38.x.x Signal at TP3 for Comformance Testing

38.6.7 Stressed Receiver Sensitivity Measurements

38.6.8 Conformance Total Jitter Measurement with Conformance Test Signal

Figure 1 Required characteristics of the conformance test signal at TP3

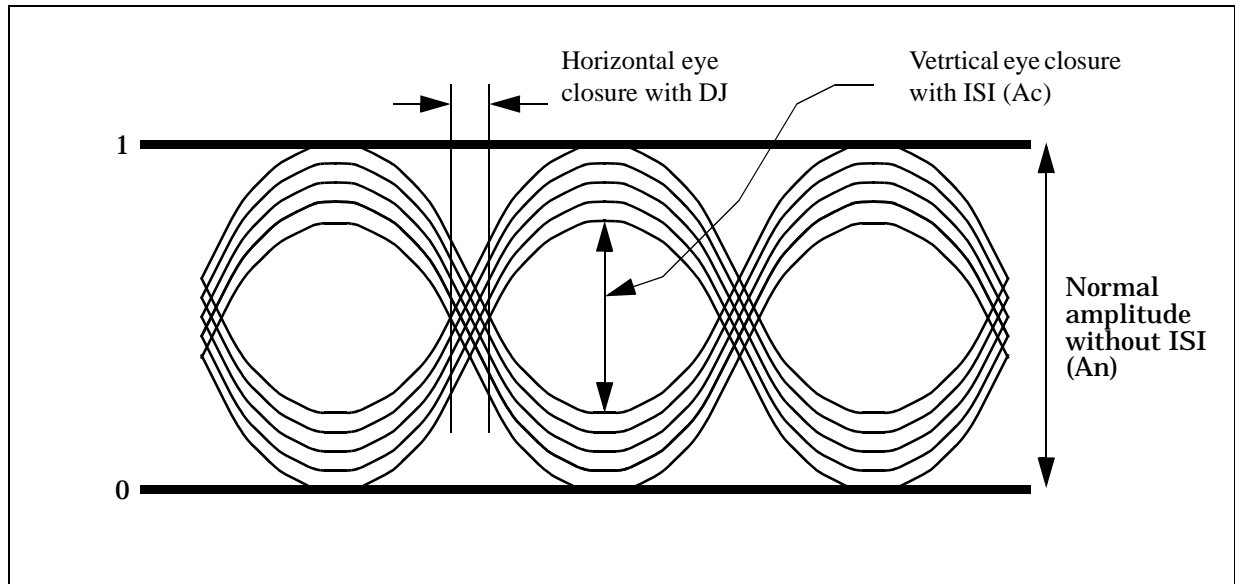
Comformance testing of receivers shall use a signal at TP3 conforming to the requirements described below. The signal used for comformance testing is conditioned by applying deterministic jitter (DJ) and intersymbol interference (ISI). The conditioned signal schematically is shown on Figure 1. The horizontal eye closure (reduction of pulse width) caused by DJ shall be no less than the amount listed in Table 1. The vertical eye closure shall be reduced by no less than the amount listed in Table 1. Note: The DJ cannot be added with a simple phase modulation.

TABLE 1. Required vertical and horizontal eye closures for the conformance test signal at TP3

fiber type	vertical eye closure [dB]	horizontal eye closure [ps]
SX-62.5 μm MMF	3.5±0.2	140
LX-62.5 μm MMF	3.6±0.2	140

Figure 2 Proposed apparatus for generating conformance test signal at TP3

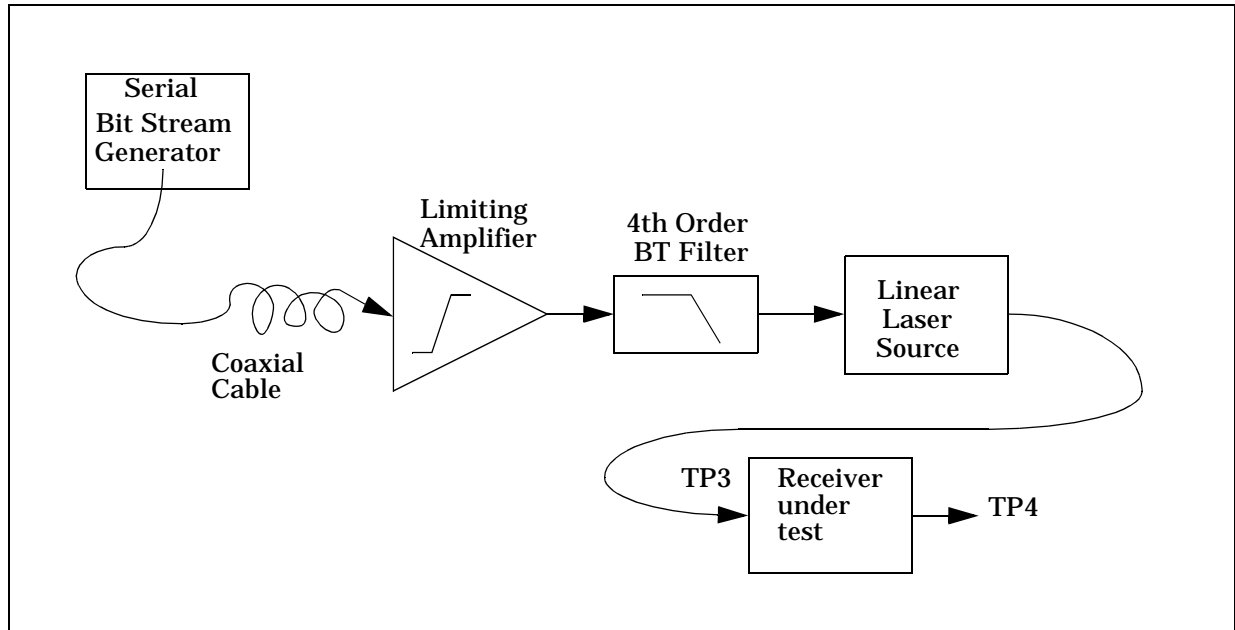
Figure 2 shows the recommended test set up for producing the conformance test signal at TP3. The coaxial cable is adjusted in length to produce the correct DJ. Since the coaxial cable can produce the incorrect ISI, a limiting amplifier is used to restore fast rise and fall times. A Bessel-Thompson filter is selected to produce the minimum ISI induced eye closure as specified in Table 1. This conditioned signal is used to drive a high bandwidth linearly modulated laser source.

The vertical and horizontal eye closures to be used for receiver conformance testing are verified using a fast photodetector and amplifier. The bandwidth of the photodetector must be at least 2.5 GHz. A 1875 MHz fourth order Bessel Thompson filter shall be used at the oscilloscope input. Special care needs to be taken to ensure that all the light from the fiber is collected by the fast photodetector and that there is no mode selective loss.

Figure 3 Experimental setup for receiver bandwidth measurement

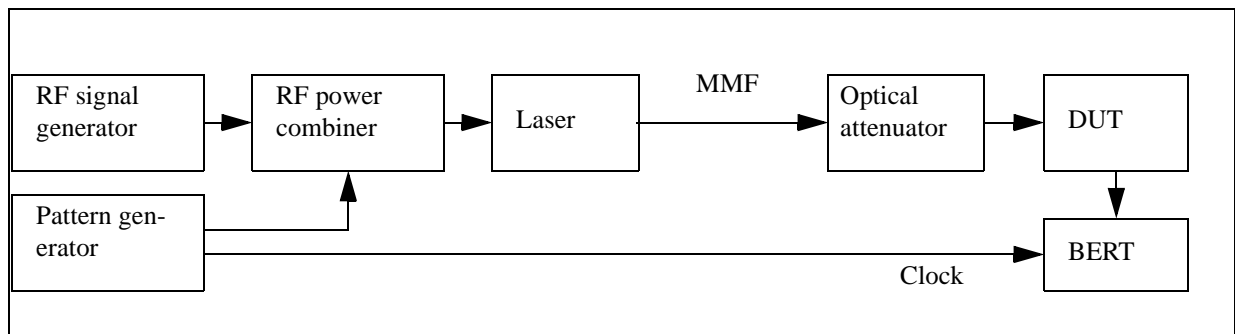
An RF signal is added asynchronously to the data stream used to modulate the laser. The laser and modulator frequency response must be calibrated to assure that an accurate measurement can be made. The steps for measuring the 3 dB bandwidth are:

1. Connect the laser output to the receiver under test through an optical attenuator and set the optical power to -12.5 dBm for SX and -13.9 for LX when no rf power is applied. This power level needs to be corrected for any difference from the minimum extinction ratio.
2. Find eye center with the error detector. Turn on the RF power while maintaining the same average optical power.
3. At every frequency being tested, measure the necessary RF signal amplitude (in dBm) required to achieve a constant BER (e.g. 10^{-6}).
4. The receiver bandwidth is calculated by adding the laser's calibrated frequency response from the measured data.
5. The receiver 3dB electrical bandwidth is the frequency where the corrected RF amplitude increases by 3 dB (electrical). Care should be taken to convert to electrical dB and to correctly compensate for the laser's frequency response.
